WORK CHANGE DIRECTIVE (WCD) NO. 4

PROJECT: ED1503 – Park Avenue from Wilkins Street to East Main Street

For changes associated adding additional 3-inch PVC pipe and two 12"x12" box inlets to drain low at Interfaith Ministries under sidewalk to street.

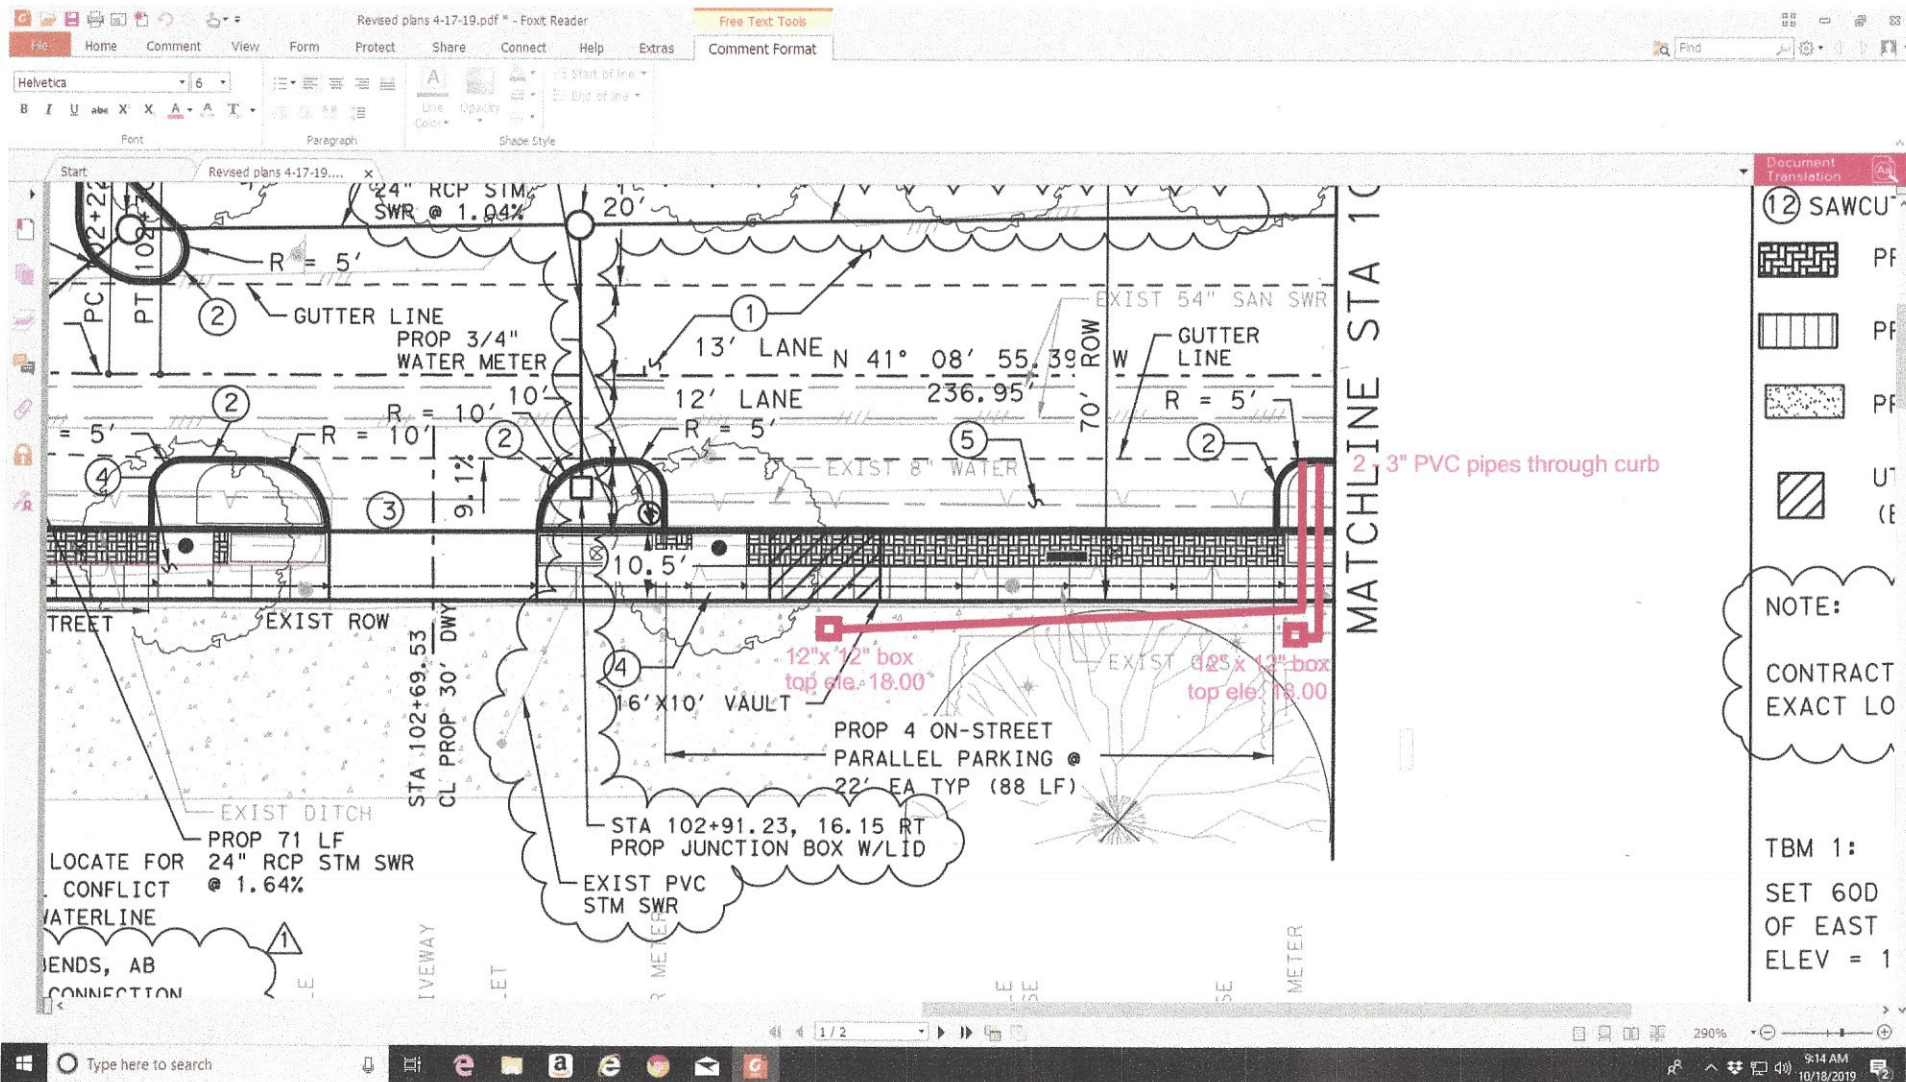
Property elevation on the east side of the road (where the very large oak tree is) between sta. 103+50 and 104+00 is very low and approximately 6" below proposed sidewalk elevations. It appears that this entire lot will not drain once sidewalk is constructed. Sidewalk cannot be lowered due to matching new street parking back of curb elevations. How is this issue to be resolved before sidewalk is built?

Response: CONTRACTOR TO PROVIDE 2 - 3" PVC PIPES
to drain through curb
